# AGENDA

## Town Planning Committee

Tuesday, 6 August 2019 at 6.30pm

NO. 35 (LOT 12) ALLEN STREET – P036/19 – TWO NEW TWO STOREY RESIDENCES

**EAST (STREET) ELEVATION HOUSE B**  
SCALE: A3@1:100

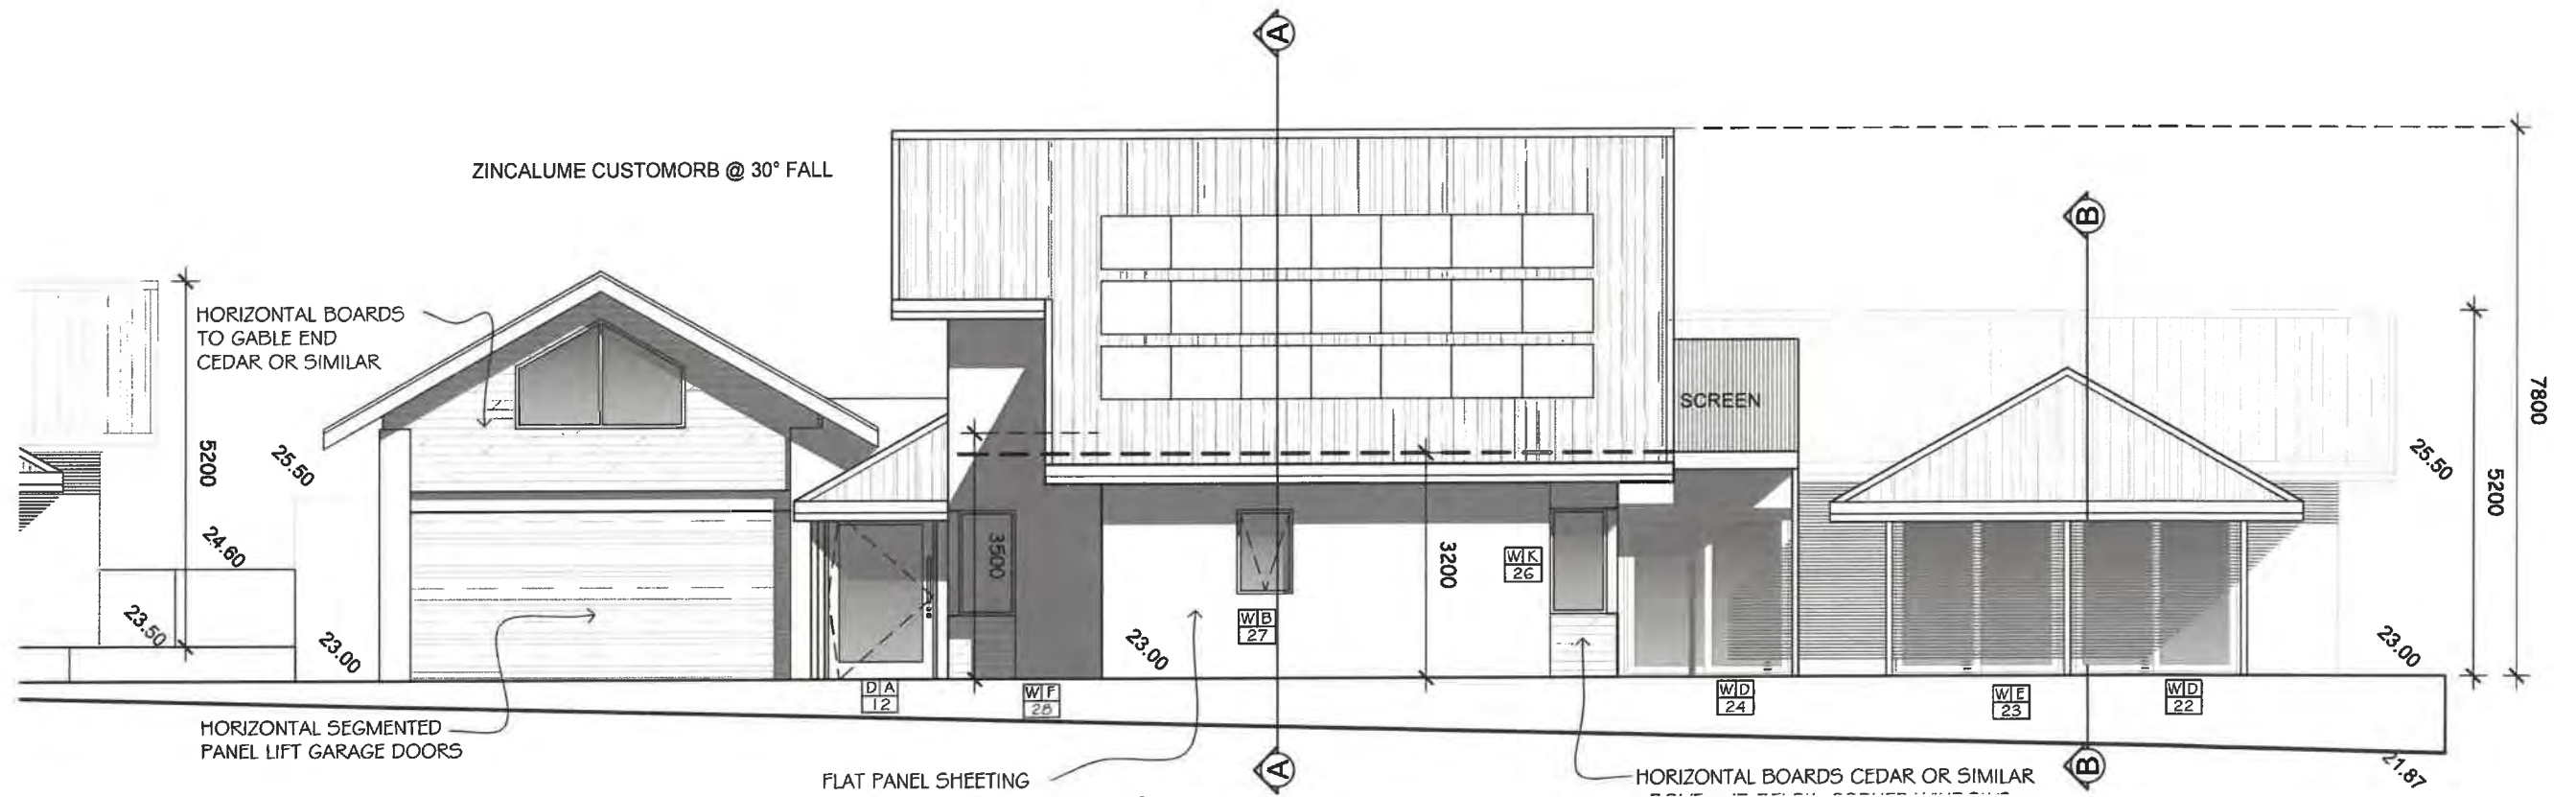
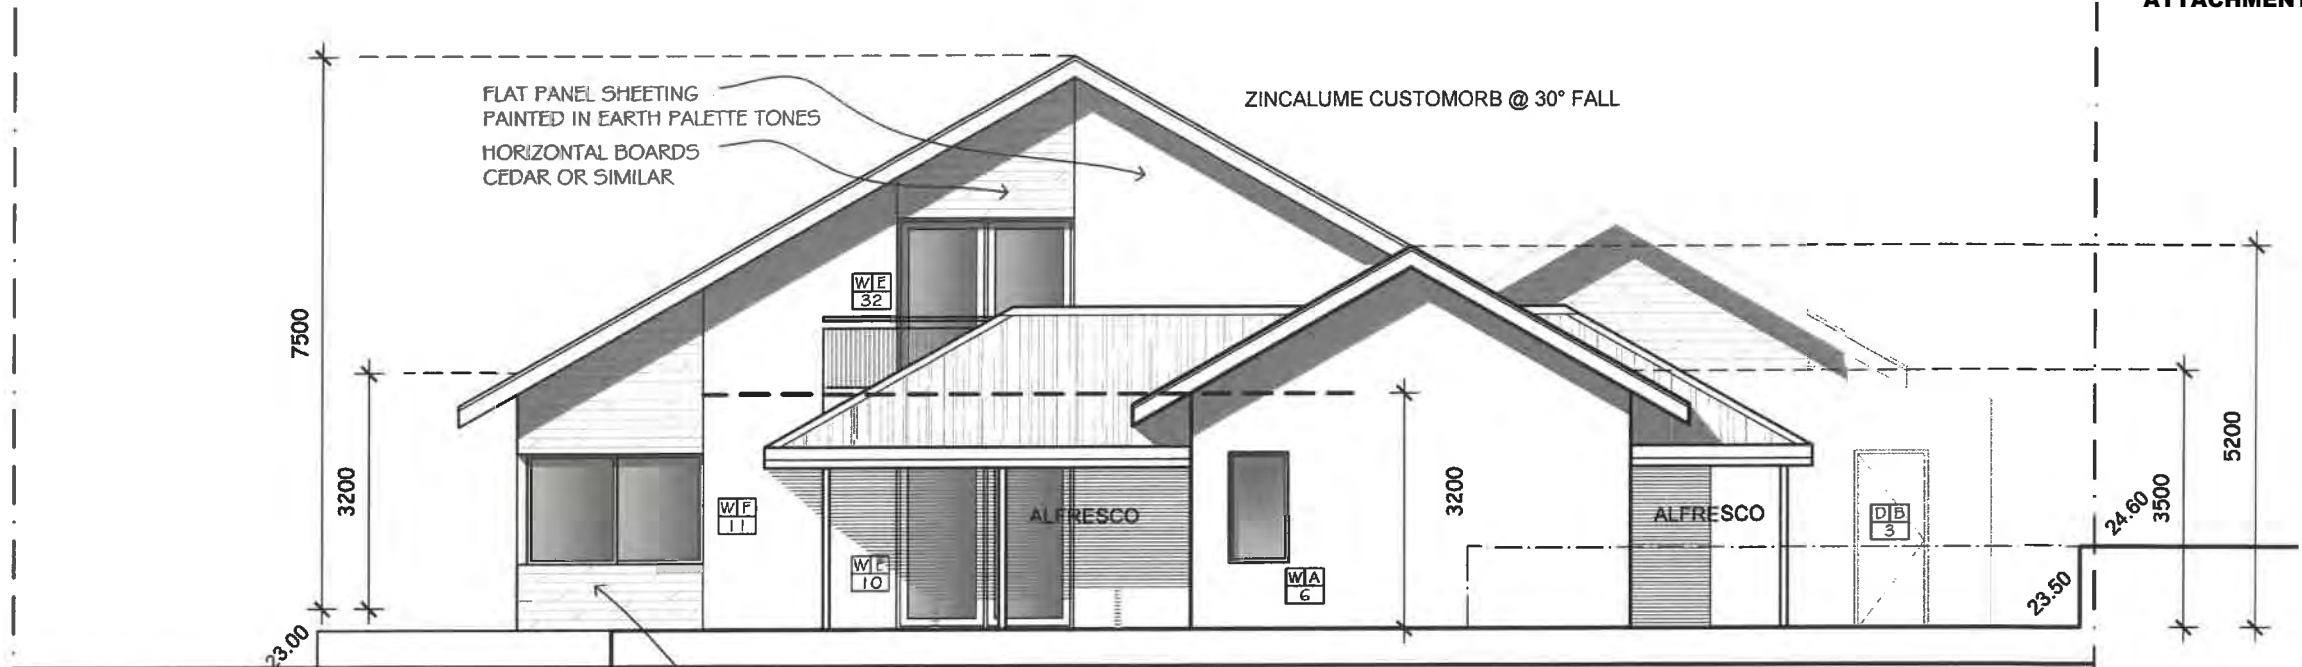
<b>Submissions</b>	<b>Applicant Response</b>
<p><b>Submission 1</b> We wish to object to the design of the proposed House B at No.35 Allen Street.</p> <p>In our original objection , which was ignored, we pointed out that the subdivision would result in two, 2 storey, houses that are not in keeping with surrounding houses and which negatively affect the amenity of their neighbours.</p> <p>What we said would happen is precisely what the current plans propose.</p> <p>In particular, House B's patio is too close to the rear fence and noise from parties, BBQ's etc. will negatively affect the amenity of the neighbouring properties.</p> <p>Additionally, on the second storey of the west elevation of House B, there is a glass door and balcony, and windows that directly overlook neighbouring properties and negatively affects our privacy. Having that much glazing on a West wall will result in heat gain, and no doubt this will result in the heavy use of potentially noisy air conditioners.</p> <p>These houses are poorly designed and don't suit the streetscape of Allen Street.</p>	<p>The original objection was to the subdivision, irrelevant to this planning application. The proposal is for single storey residences with a roof attic master bedroom suite. It should be noted that one neighbour at 1B Fletcher St has a modern two storey home.</p> <p>Almost all outdoor entertaining areas (which are a requirement of the R-Codes) are by definition near boundaries, as the house itself is required to be setback. That said, the House B roofed alfresco is setback from the rear (west) fence 2.2m.</p> <p>The upstairs deck of House B is 5.69m from the north boundary. This is less than 7m, however it is clearly labelled and drawn as "screened" on plans and elevations as per the R-Codes requirements for less than 7m Windows facing west, or any other direction, is completely irrelevant. Windows have to face somewhere.</p> <p>The development generally complies with the Deemed to Comply provisions and entirely complies with the scope of the Design Principles of the R-Codes, and thus meet the accepted definition of "good design". The only appreciable difference to SOME of the other residences is that it has gable roofs instead of hipped roofs - normal roof pitch and large overhangs in keeping with the street, ridge heights of 7.35m are entirely in keeping with the street, the roof material is the same as three of its immediate neighbours and much of the street, there is a high degree of articulation in keeping with the street, the front fence is in keeping with the majority of the street, and the proposed earthen tone colours are in keeping with the street.</p>

<b>CDAC Comments</b>	<b>Applicant Response</b>	<b>Officer Response</b>
<p>(a) The overall built form merits;</p> <ul style="list-style-type: none"> <li>The Committee note there is no outstanding design merit in the proposal. The proposal does not display significant architectural design suitable to the area.</li> <li>The Committee recommend that no variations should be granted for the development proposal considering the design of the dwellings is not to a high architectural standard.</li> </ul>	<p>The committee has made no objective determination on the merits of the overall built form, rather a vague subjective criticism. In keeping with mollifying concerns expressed by initial advertising responses to the subdivision, the overall built forms are essentially single storey residences with an attic space master bedroom suite rather than two storey dwellings as allowed by the R-Codes and TPS, provides a maximum of outdoor area for a minimum footprint, heights are considerably less than those allowed for in the R-Codes, roofs are pitched similarly to the surrounding houses rather than an allowed flat modern outcome, there is considerable articulation and overhangs, there are very large outdoor areas, and there are no overlooking or overshadowing considerations.</p> <p>Further, the overall subdivision and house design provides for two distinct single story residences with a street frontage of one house, rather than a possible street frontage of two co-joined two storey residences which was an allowable possibility.</p>	<p>If a dwelling design meets the deemed to comply requirements of the R Codes or achieves the design principles of the R Codes then there is no reason for Council to refuse the proposed development.</p> <p>Likewise if the proposed development meets the acceptable development provisions or achieves the performance criteria of the Residential Design Guidelines then there is no reason to refuse the proposed development.</p> <p>However, the character of the area is acknowledged. 36 dwellings in Allen Street are listed on the Heritage List or MHI. The design is simplistic and has been designed so as to not conflict with the prevailing design in the street or with the existing character. The design is considered consistent with the character of existing lot frontages.</p> <p>The architectural merit of the design is not judged separately as part of the planning approval process but as a whole with the planning requirements.</p>

- *The roof pitch has been increased to 30 degrees*
- *A colour swatch has been included with olive, plum, tan and cream colours to demonstrate proposed colours.*
- *A hipped roof has been added over bedroom 3 and a pitched roof has been added above the front entrance*
- *Flat rooves have been replaced with pitched rooves*
- *Setbacks have increased to the southern boundary*
- *Zincalume customorb roof is proposed in line with all the metal rooves of the traditional houses in the street*

- The roof pitch has been increased to 30 degrees
- Colour swatch has been included with olive, plum, tan and cream colours.
- A hipped roof has been added over bedroom 3 and a pitched roof has been added above the front entrance
- Flat rooves have been replaced with pitched rooves
- Setbacks have increased to the southern boundary
- Zinalume customorb roof is proposed in line with all the metal rooves of the traditional houses in the street
